MIDVALE PLANNING AND ZONING COMMISSION MEETING AGENDA MAY 11, 2016

1. SSMP-21-26-227-003; MAVERICK CONVENIENCE GAS STORE; 7148 SOUTH BINGHAM JUNCTION BOULEVARD; SMALL SCALE MASTER PLAN FOR 24-HOUR AUTOMOTIVE FILLING STATION AND CONVENIENCE STORE; RICK MAGNESS/MAVERICK, INC. (APPLICANT)

Planning and Zoning Commission Staff Report

APPLICATION:	MAVERIK – BINGHAM JUNCTION & JORDAN RIVER BOULEVARD
LOCATION:	7148 S. Bingham Junction Boulevard
APPLICANT:	Maverik, Inc. C/o: Rick Magness, Senior Entitlements Manager
FILE #:	SSMP-21-26-227-003
REQUEST:	Small Scale Master Plan / Admin. Conditional Use Permit
MEETING DATE:	Wednesday, May 11, 2016
ZONING DESIGNATION:	Bingham Junction/Riverwalk Overlay – Subarea 2 (BJ/RWO)
AUTHOR:	Matt Hilderman, Associate Planner
APPLICABLE ORDINANCE (S):	17-7-9, 17-7-9.12.1.6-1.8
AGENDA #:	1

SHEET TITLE
LANDSCAPE PLAN

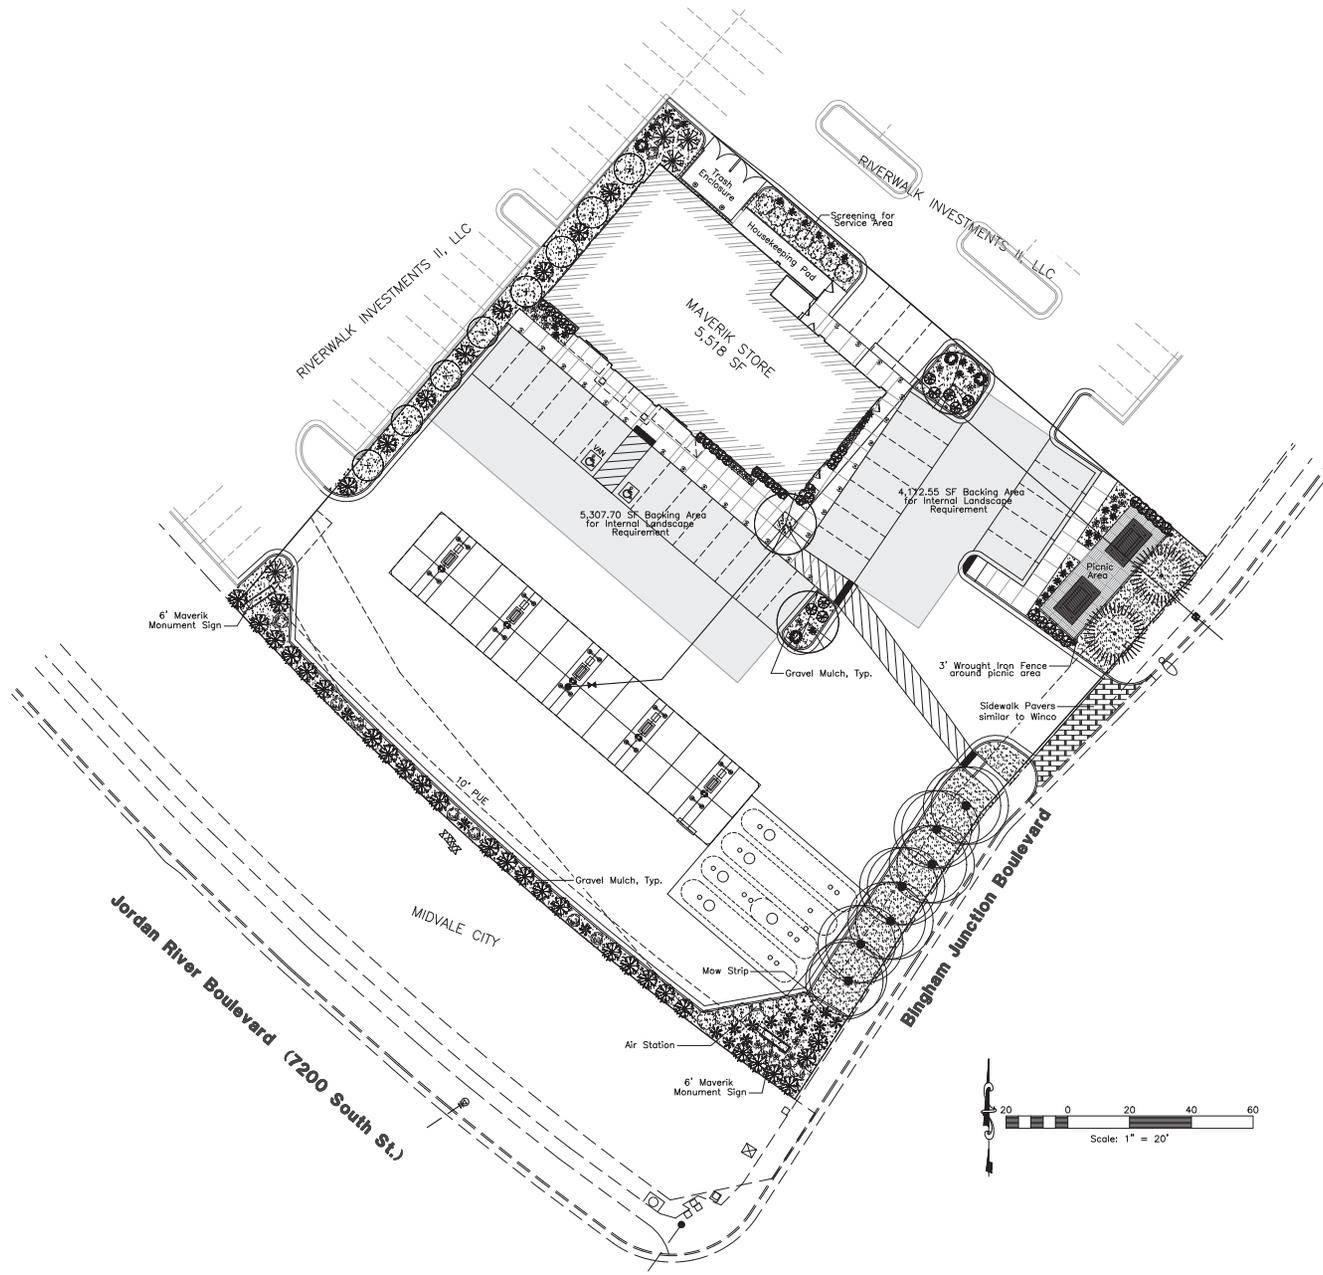
4. *The landscape plan shall address the following items:*
 - *The applicant shall remove the two (2) proposed ‘Austrian Pine’ evergreen trees proposed with the landscaped setback.*

- *The interior parking lot landscaping calculations shall be revised to ensure compliance with the minimum 10% landscaping requirement.*
 - *The proposed ‘sidewalk pavers’ shall be stated as the following, “Stamped concrete crosswalk detail needs to include the expected pattern (Ashlar) and integral color (Dark Gray CC230/4 – Color-Crete or equivalent.” This is one of the required thematic elements for Riverwalk.*

LANDSCAPE DETAILS

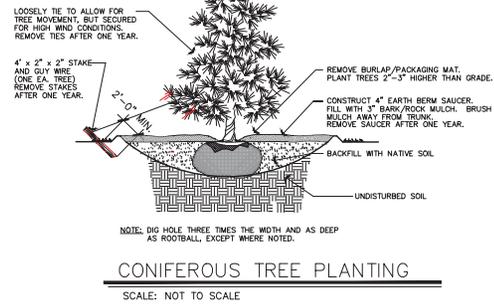
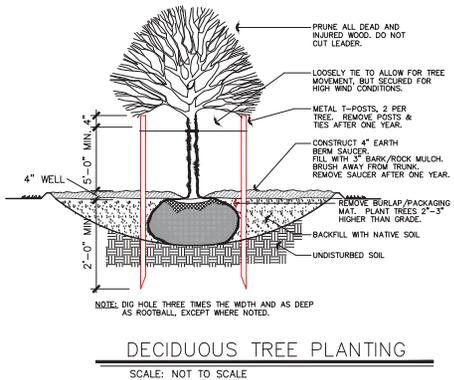
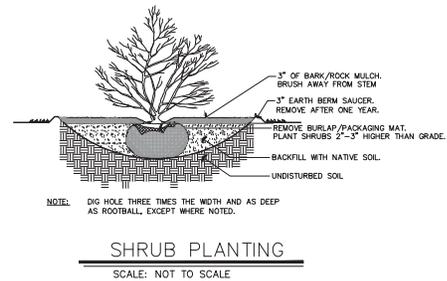
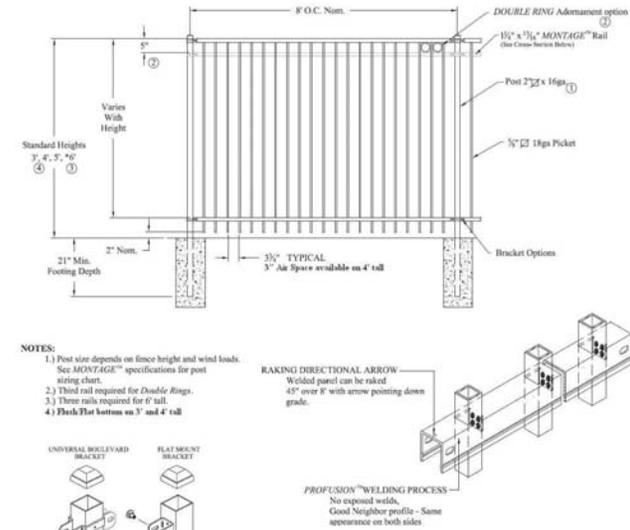
- A twenty-foot (20') landscaped buffer setback shall be required adjacent to Bingham Junction Boulevard.
- Changes to 'Sheet L2 Landscape Details' stating the following, "4" layer of 1" crushed rock mulch."
- An irrigation schedule, as stated on 'Sheet L3 Irrigation Plan' for further review.
- A detail of the trash enclosure, including materials and colors that match the building and a screening gate.
- A revised 'interior parking landscaping plan' that identifies the appropriate parking lot landscaping areas.
- The proposed 'sidewalk pavers' shall be stated as the following, "Stamped concrete crosswalk detail needs to include the expected pattern (Ashlar) and integral color (Dark Gray CC230/4 – Color-Crete or equivalent." This is one of the required thematic elements for Riverwalk.

- *Changes to ‘Sheet L2 Landscape Details’ stating the following, “4” layer of 1” crushed rock mulch.”*
 - *An irrigation schedule, as stated on ‘Sheet L3 Irrigation Plan’ for further review.*
